TO ALL BIDDERS OF RECORD:

This Addendum forms a part of the Contract Documents and modifies the Drawings and Project Manual as hereinafter indicated.

(THIS COMPLETES ADDENDUM NO. 2)

Dedham-Westwood Water District
Storage Facility and Site Improvements

Project Number. 6790
Drawing No. **C002**

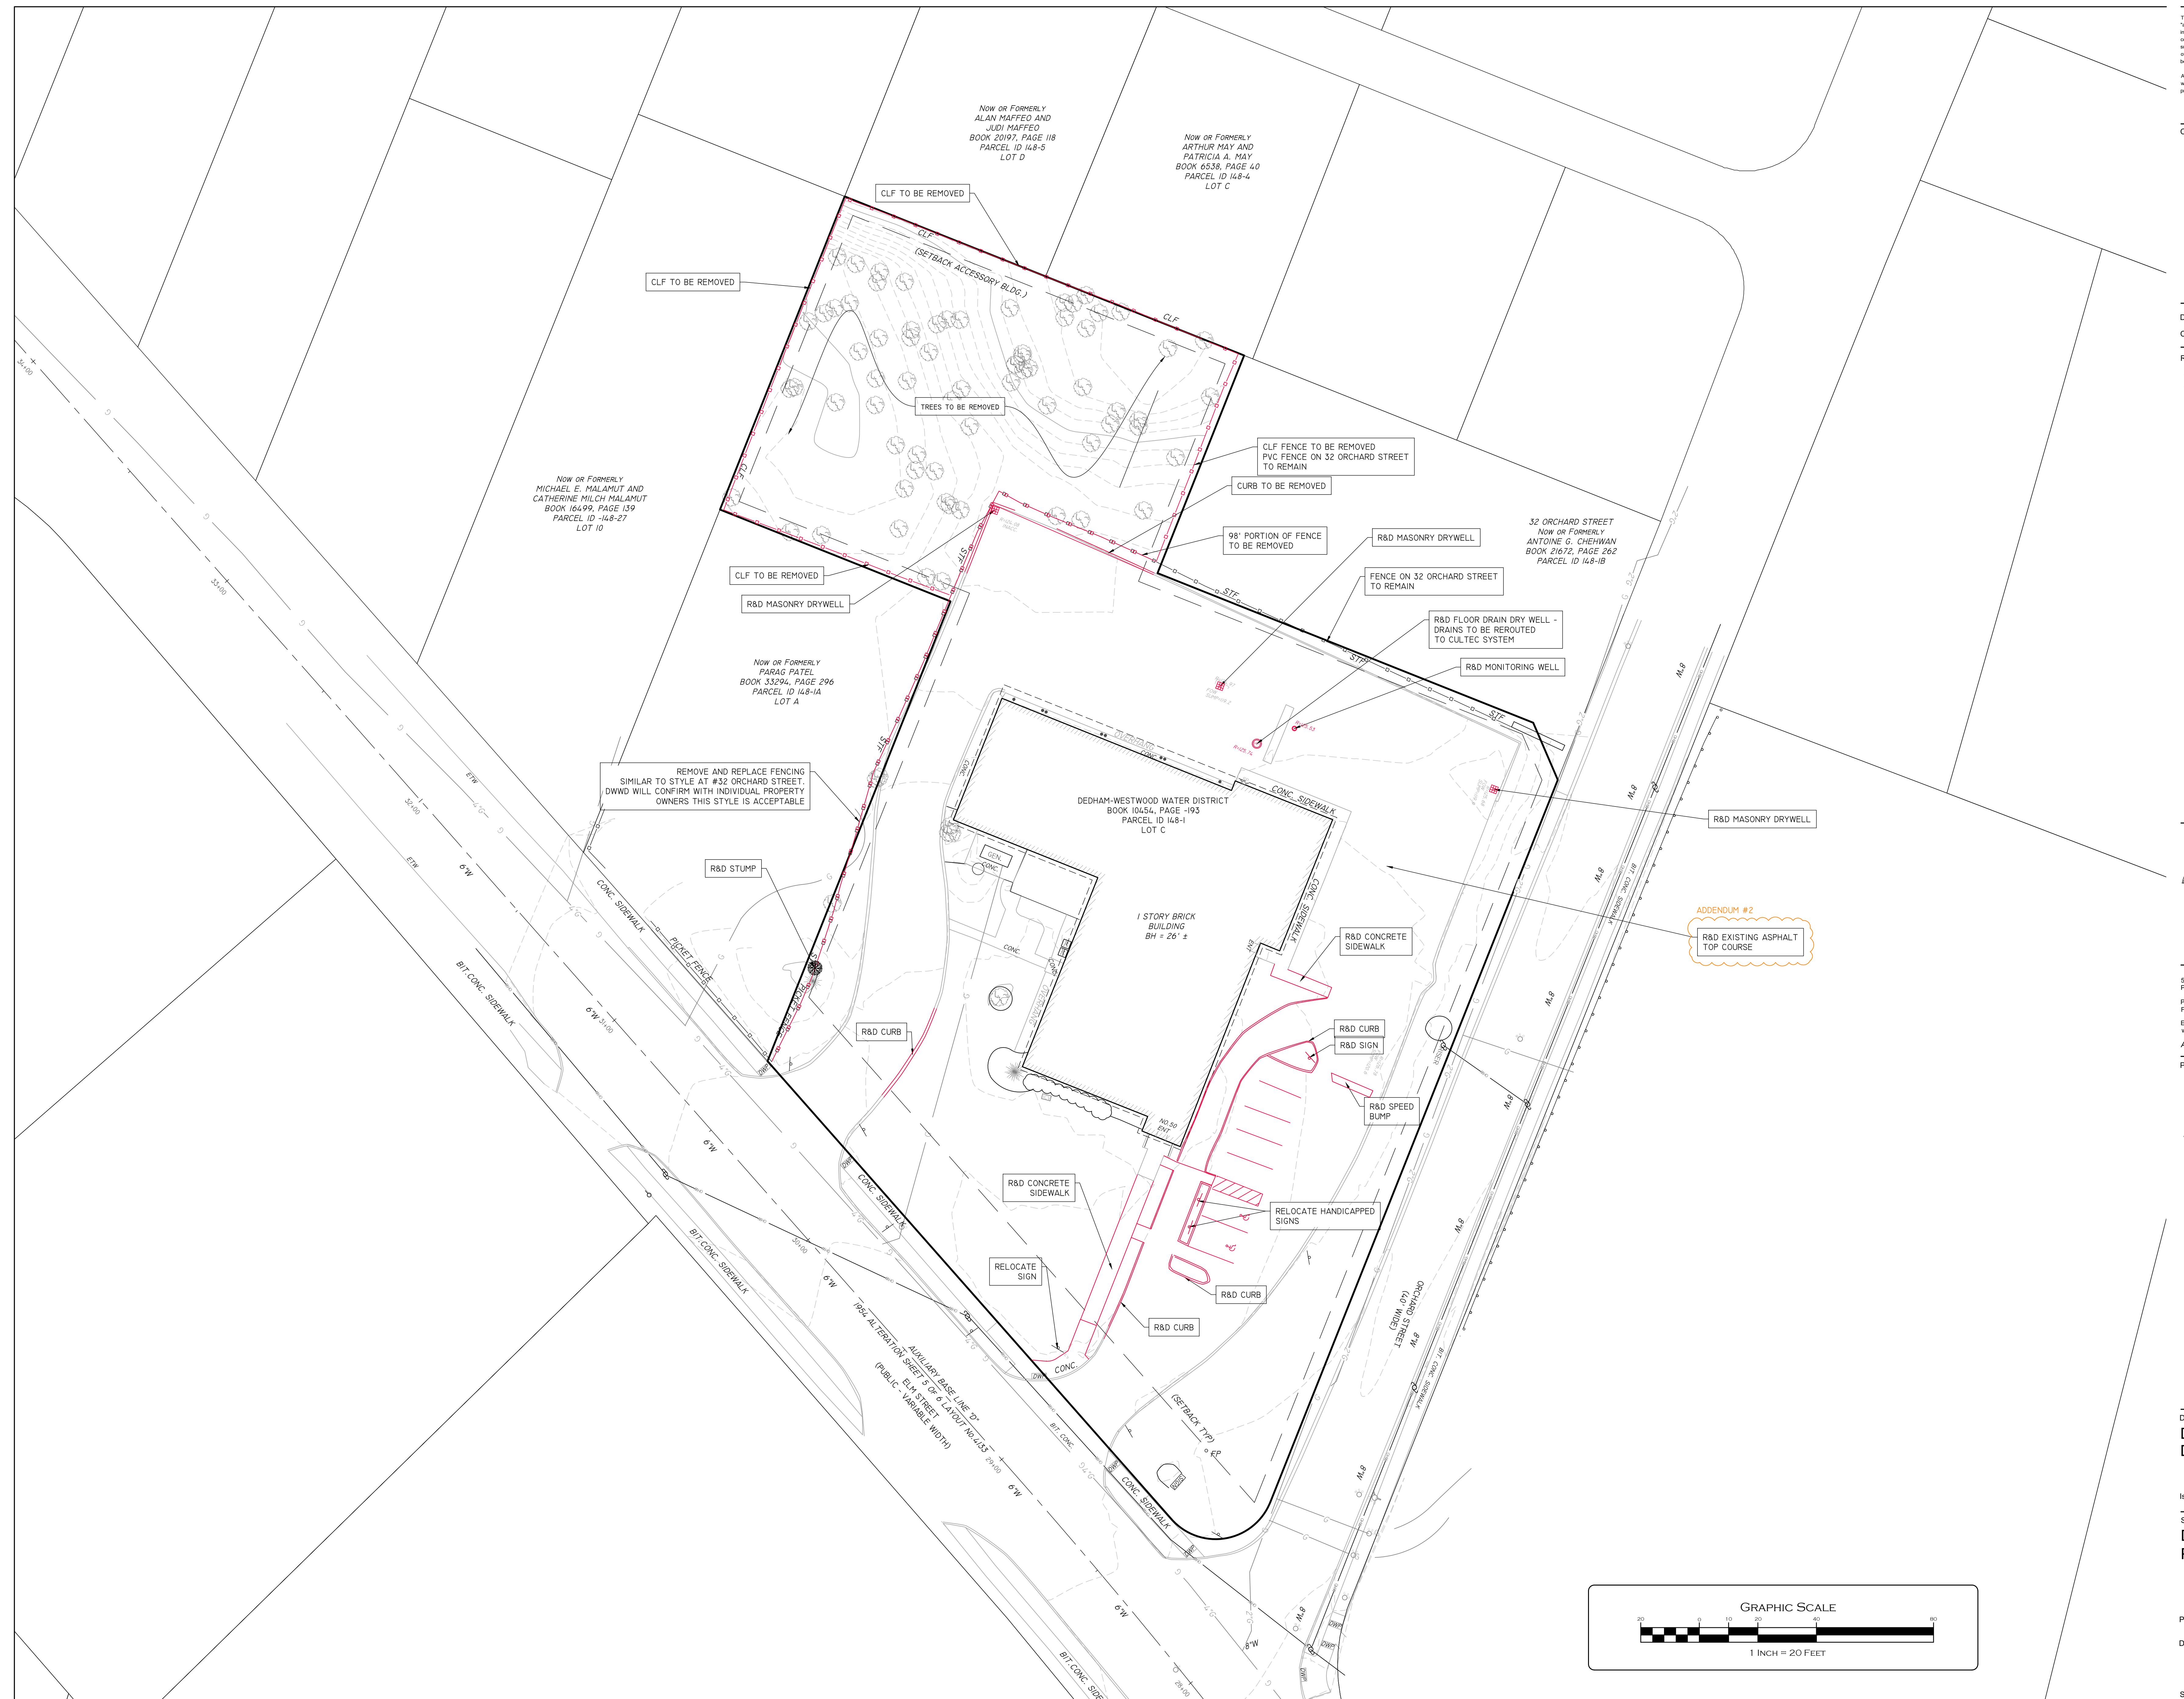
1. *Sheet C002- Demo plan- since there will be new and resurfaced asphalt- is there any existing asphalt paving that needs to be demolished? If so, please indicate on plans.*

Response: Existing asphalt will be disturbed under project scope. Regard the revised Sheet C002 and C003.

PAVEMENT, SIDEWALK AND WALKWAY DETAIL
NOT TO SCALE

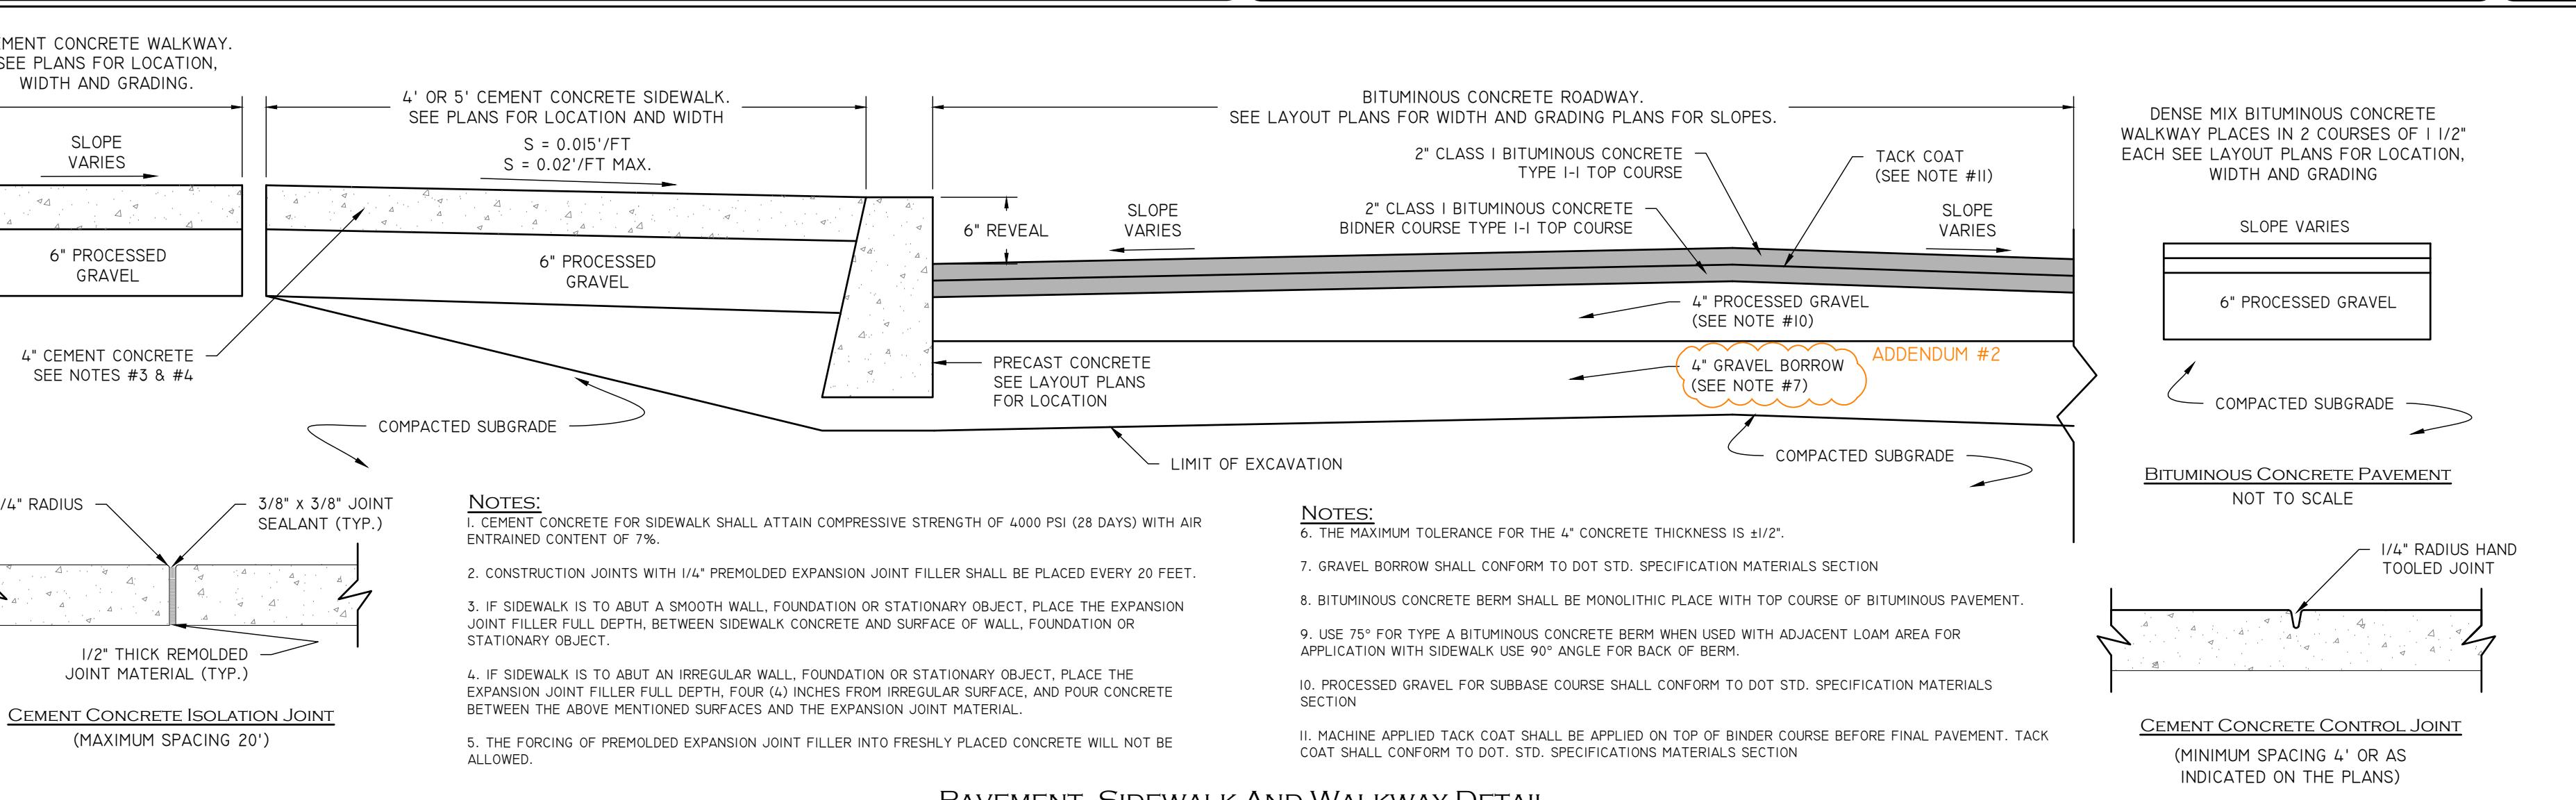
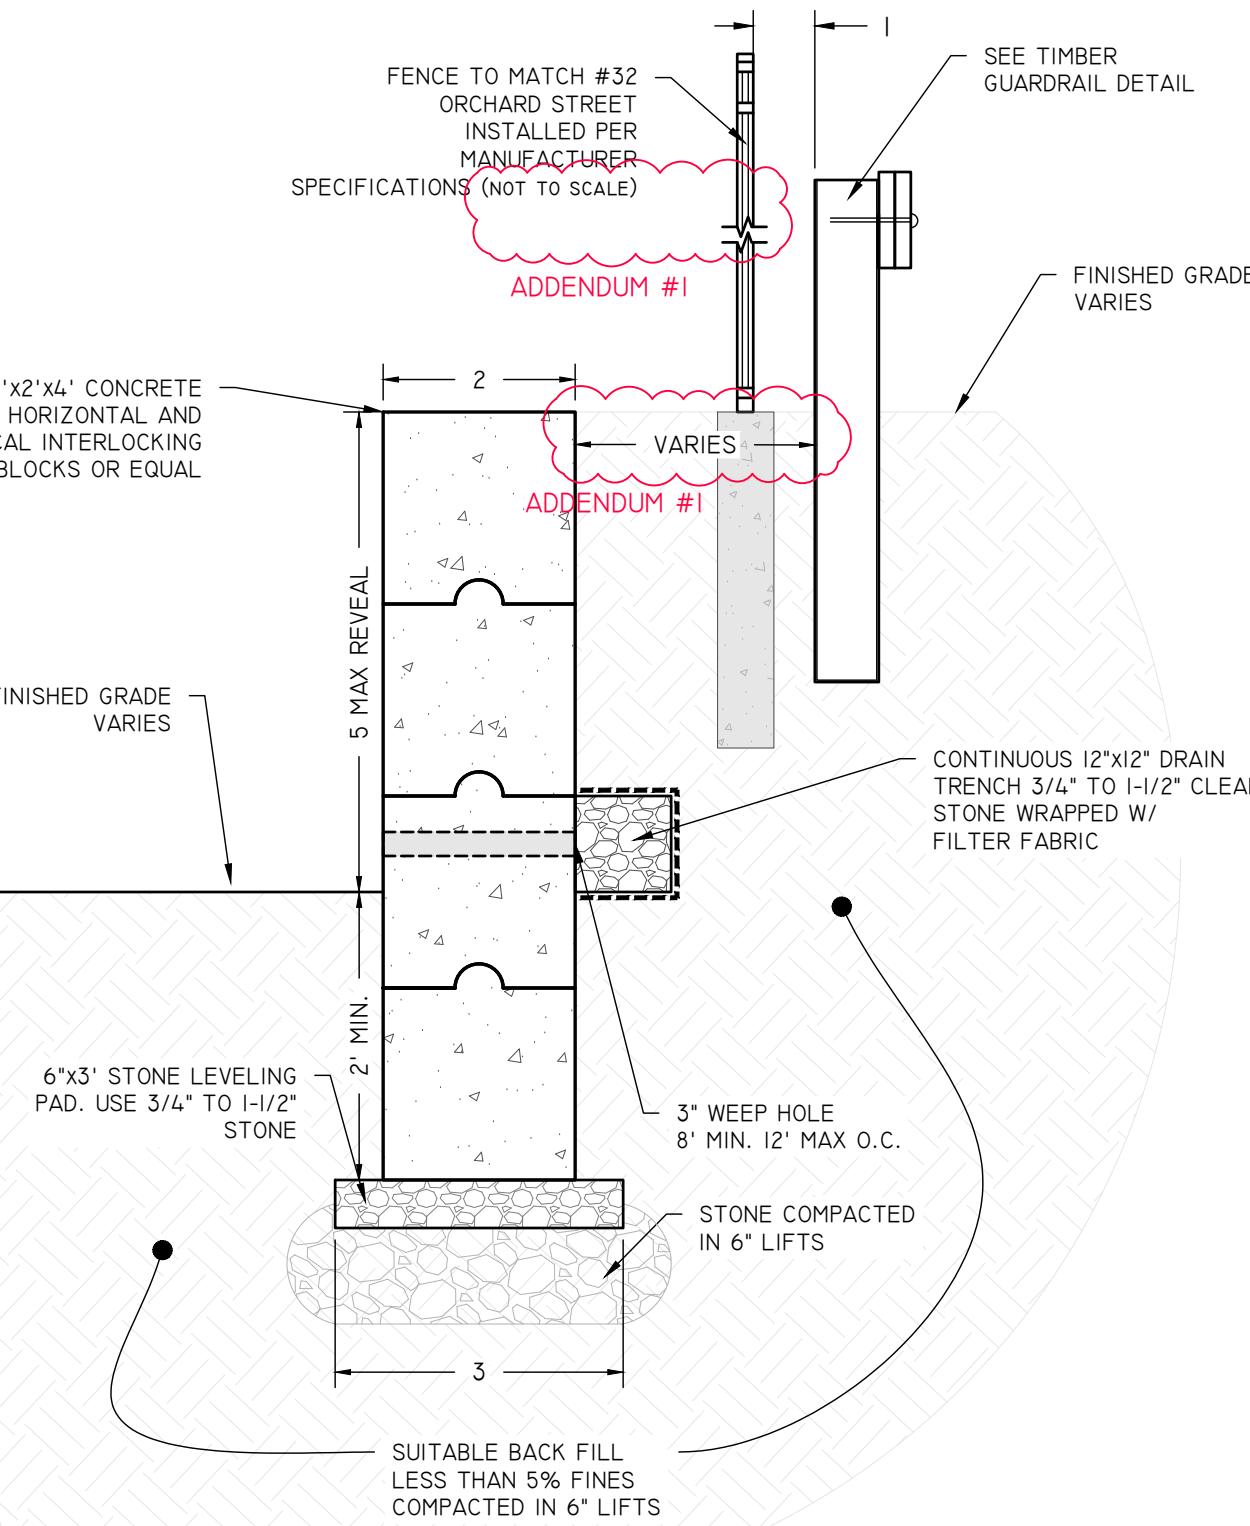
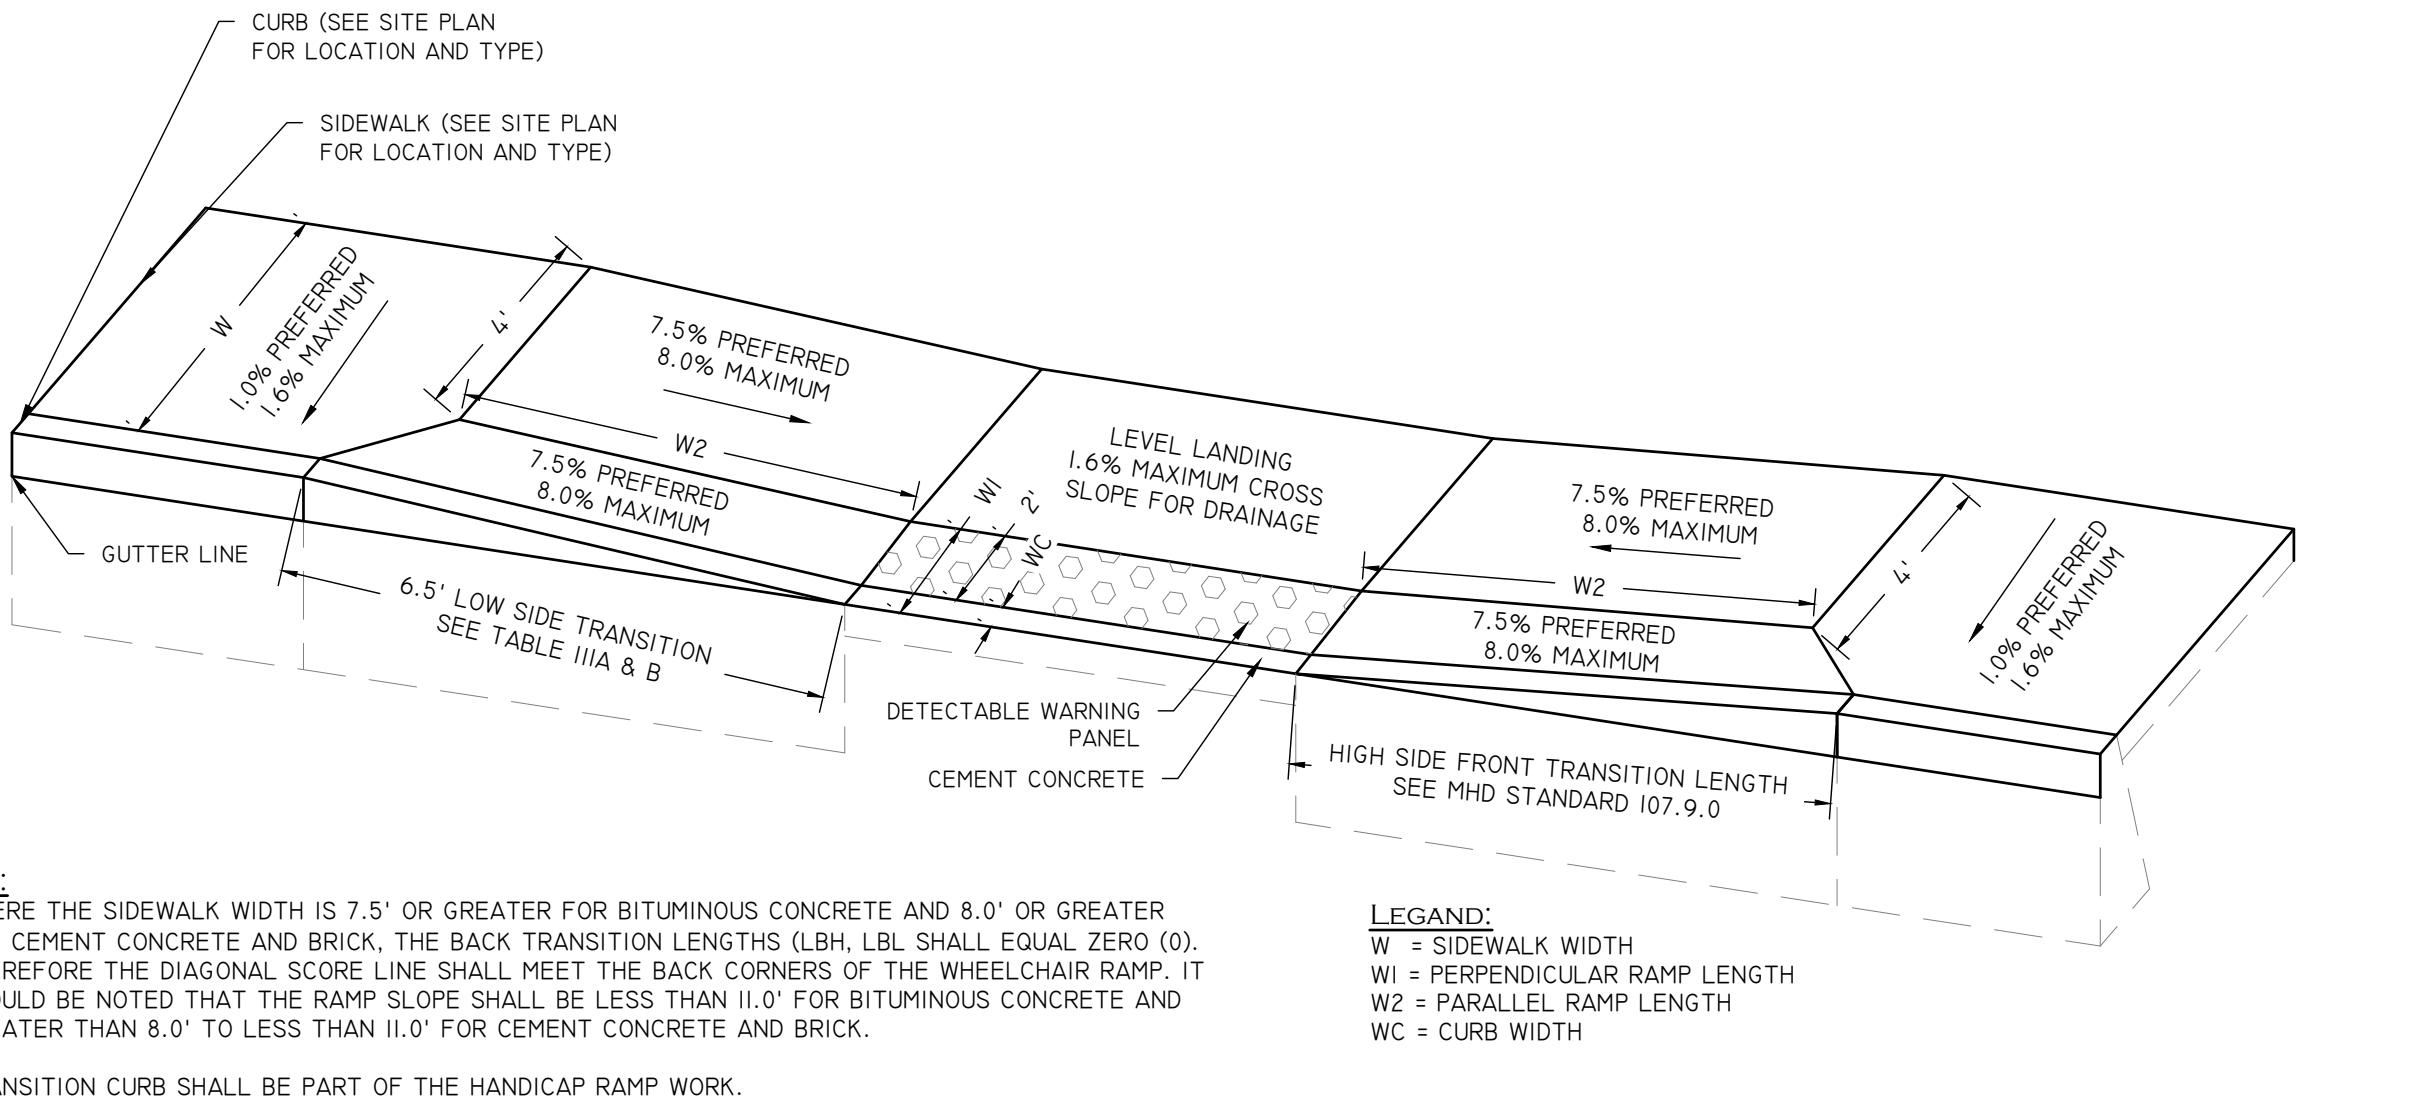
2. *The civil details for asphalt pavement show 2 details- one with 4" asphalt and 12" bedding, the other with 4" paving and 8" bedding- which one is correct?*

Response: Based on use and loading conditions. Regard Sheet C006 w/ 4" asphalt and 8" of bedding material.
